Re: Air Construction Permit Application, Dated February 15, 2000
Project: Batch Reactor System
DEP Project No.: 1030207-003-AC
Location: TSE Industries, Inc., 5260 113th Avenue North, Clearwater, Pinellas County.

Re: TSE Industries Inc., 1030207-003-AC - Construct Toluene Diisocyanate Dimer Batch Reactor

TSE Industries, Inc.
 Process Diagram - Batch
 Reactor System

**RE: Request for Maximum Achievable Control Technology Determination
Batch Reactor System for Production of *Thanacure T9*
FDEP Project No.: 1030207-003-AC
Project Location: TSE Industries, Inc., 5260 113th Ave. N., Pinellas County**

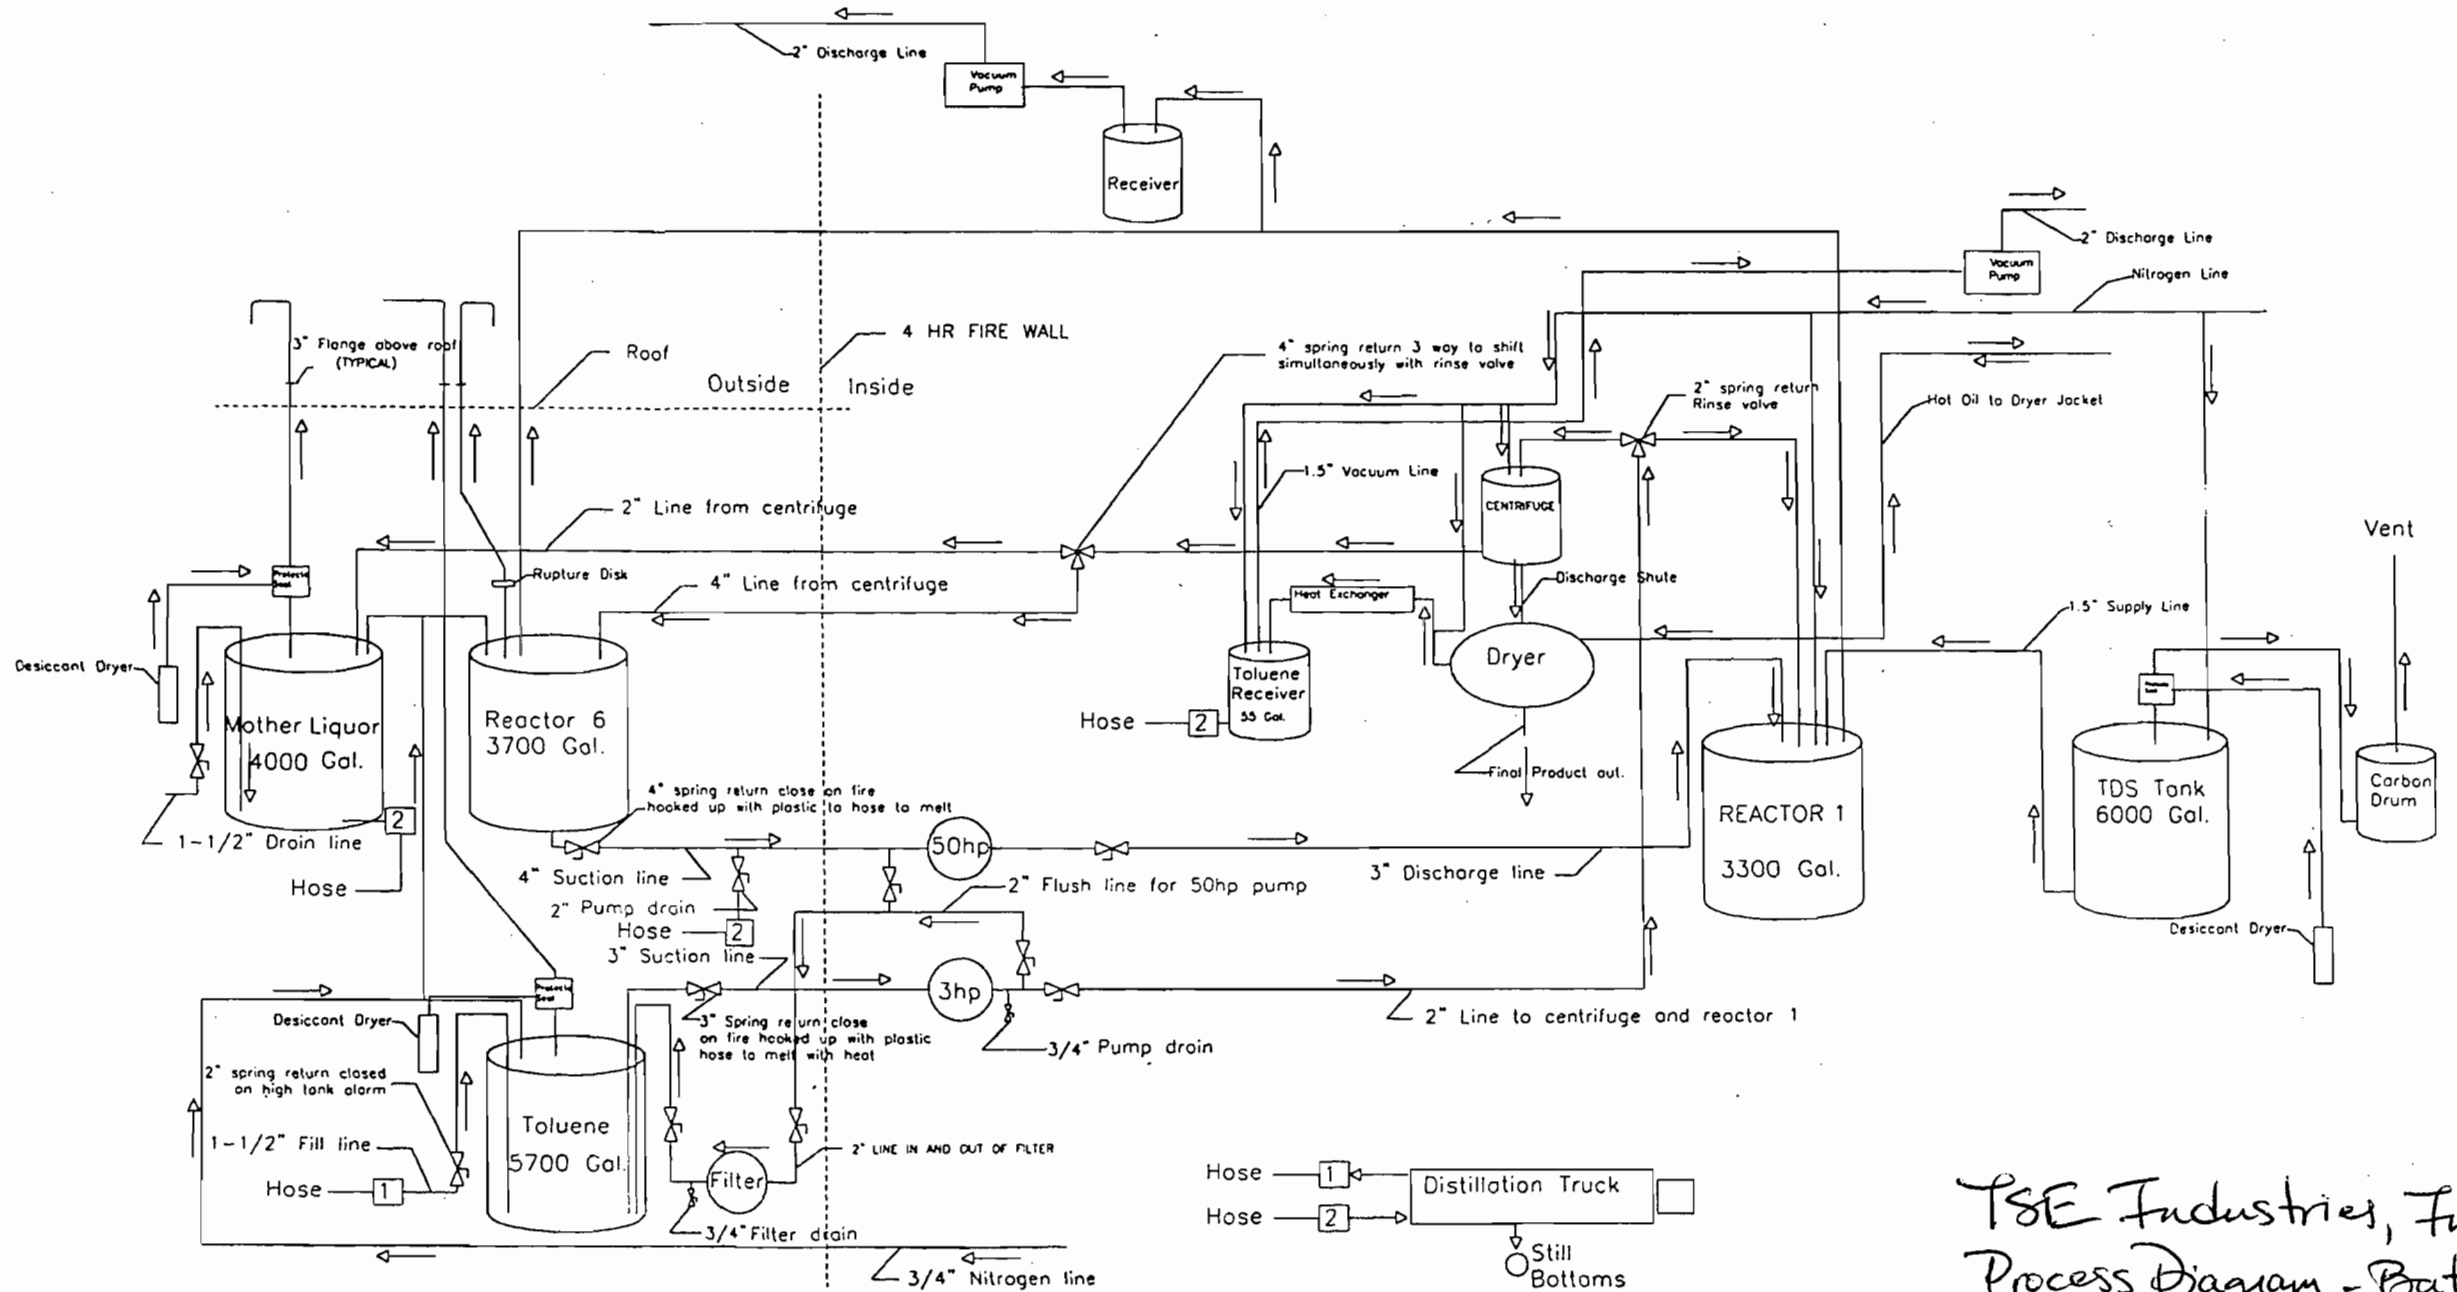
- C. The process flow chart shows Reactor 1 and a Reactor 5. Are there Reactors 2-4?
 - D. The process flow chart shows a "Mother Liquor", what is this.

6. The 3/20/00 inspection mentions a drying process after the centrifuge, however none is shown on the process diagram. Is there a dryer? If so a new process diagram is required.

2. Please update the plot plan to show the distillation process for the recovery of toluene from the mother liquor.

5. The tanks description in the response letter dated May 19, 2000 (item 8.4.B) and the revised plot plan do not correspond. Please clarify.

5. Reactor #6 contains the "Mother Liquor", supernatant and first rinse of the T9 production process. The tank labeled *Mother Liquor* on the Process Diagram is actually the Rinse tank (2nd and 3rd toluene rinses of T9 process). These tank nomenclature have been in place at TSE for several years. Please excuse any inconvenience. Be aware that all reactor volumes given are approximations.

TSE Industries, Inc.
 Process Flow Diagram
 Batch Reactor System

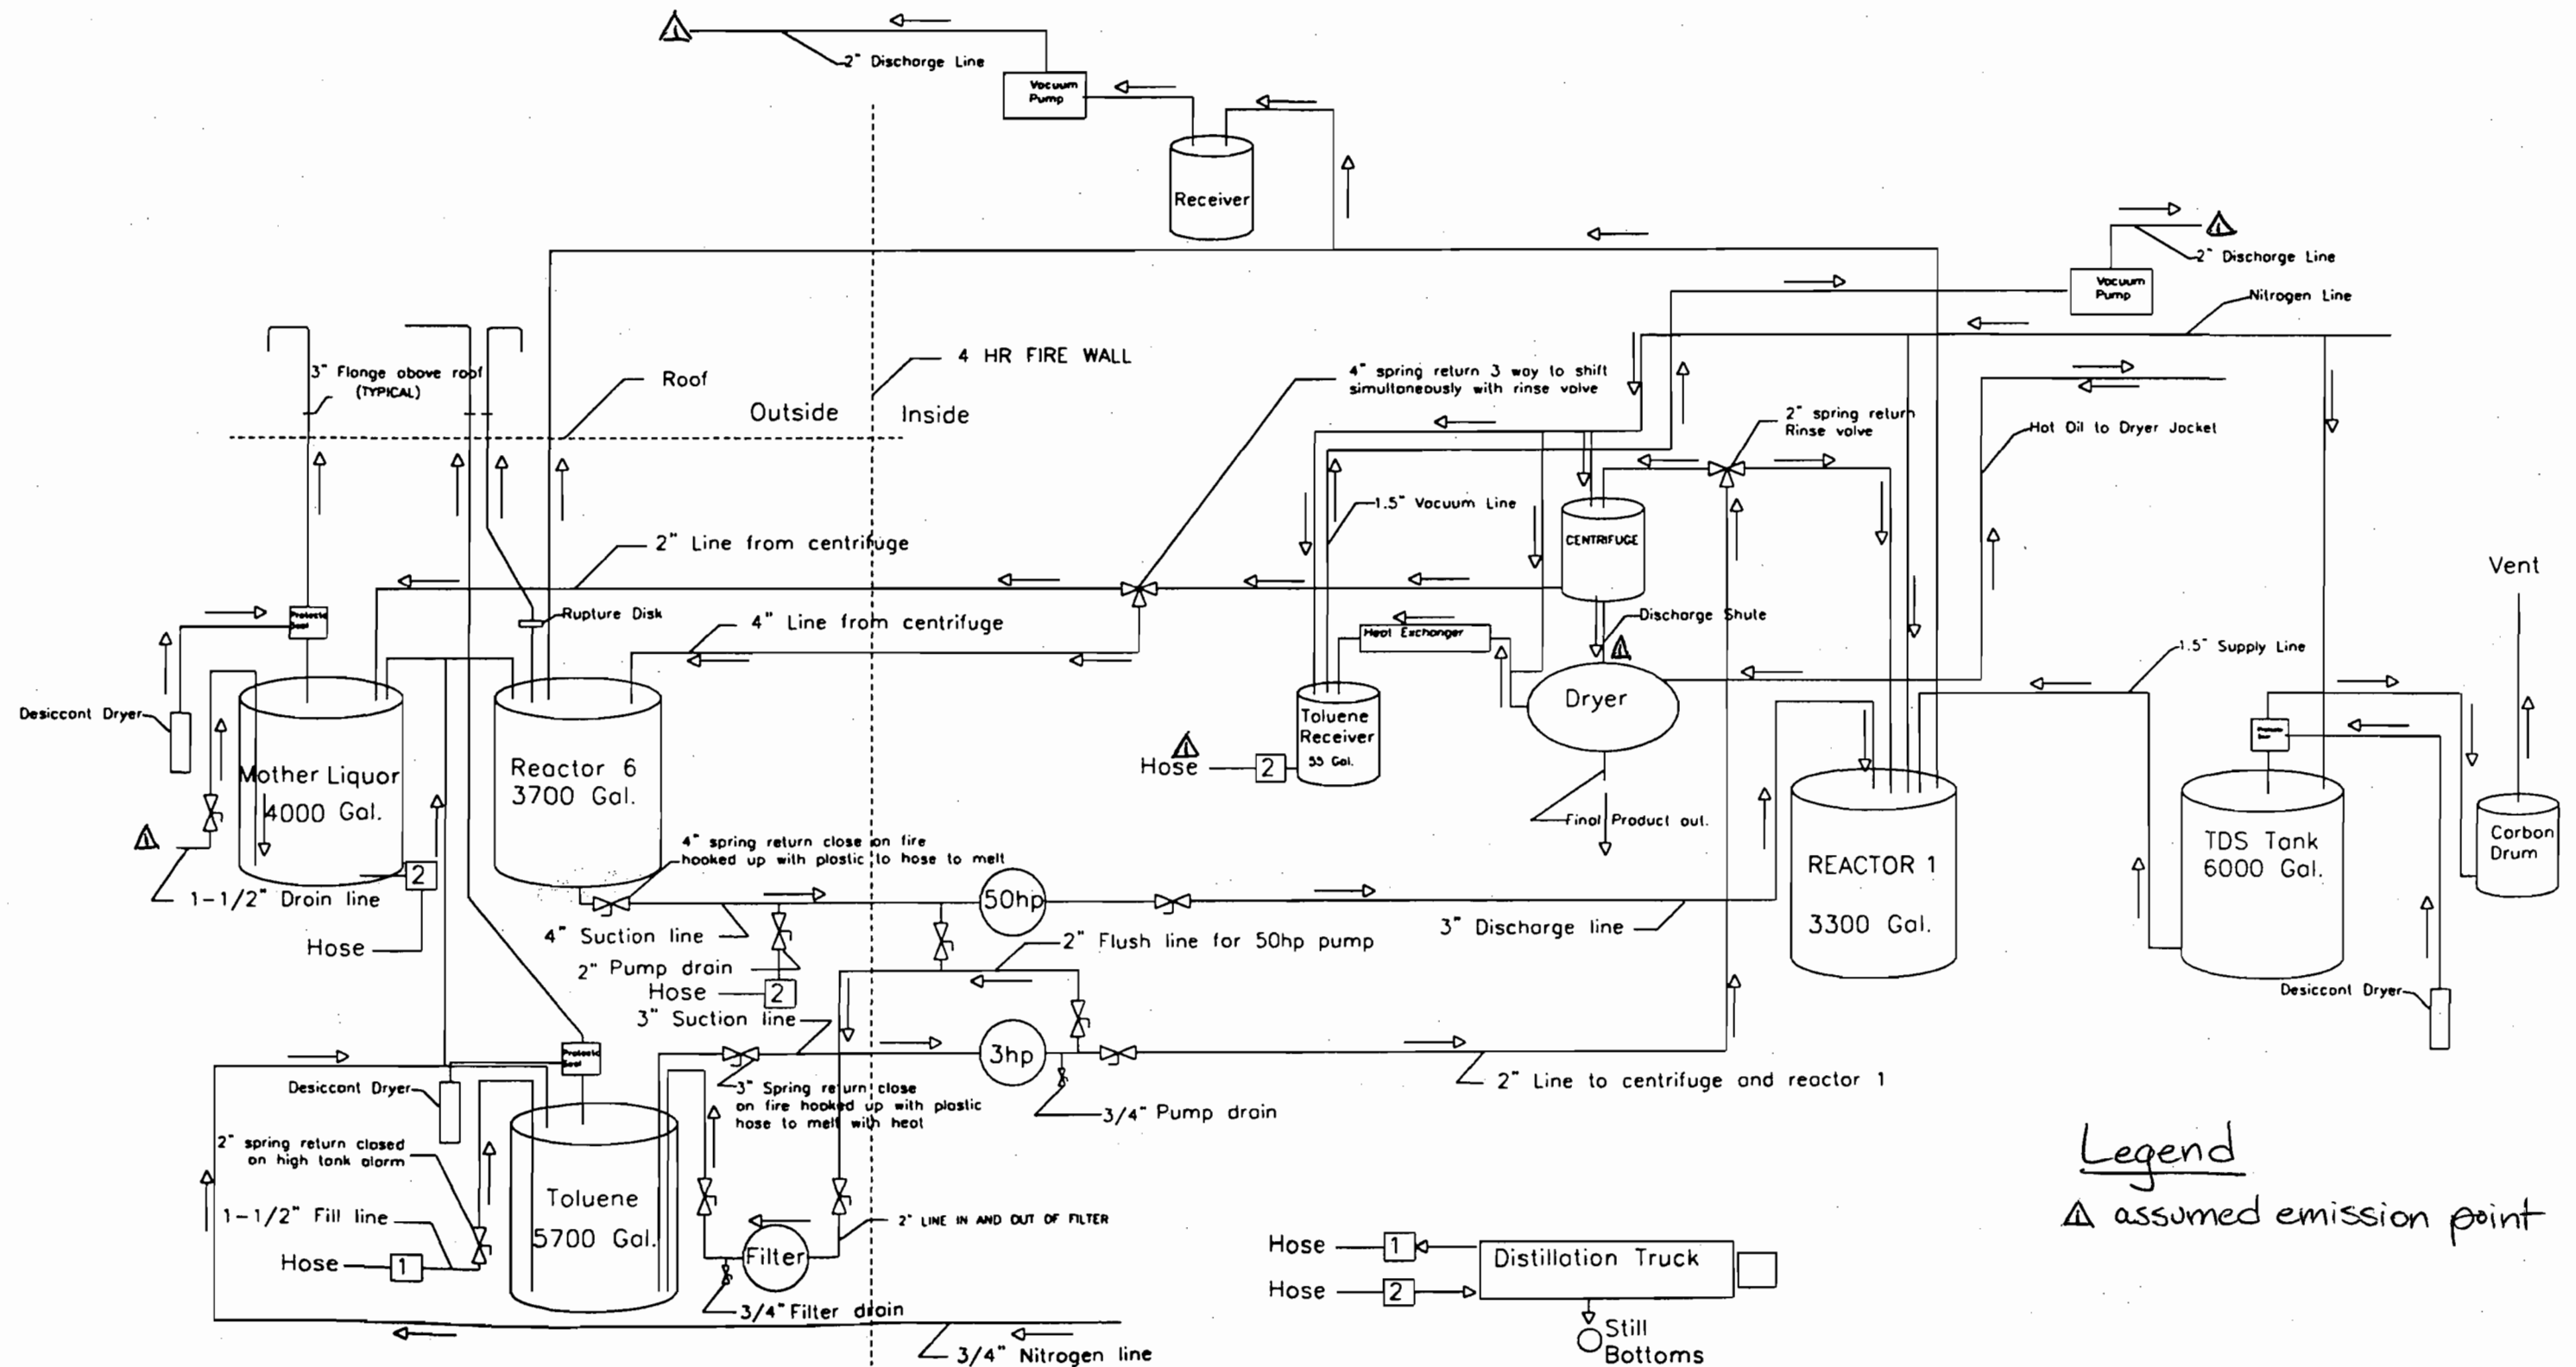
1. During our meeting and walk-through at the facility, we found that the process-flow diagram submitted with the application (and, later, in response to a request for more information) was apparently incorrect with regard to flow directions, as we discussed. Please review the diagram, make the necessary corrections, and ensure that all relevant equipment, connections, and flow-directions are accurately represented.
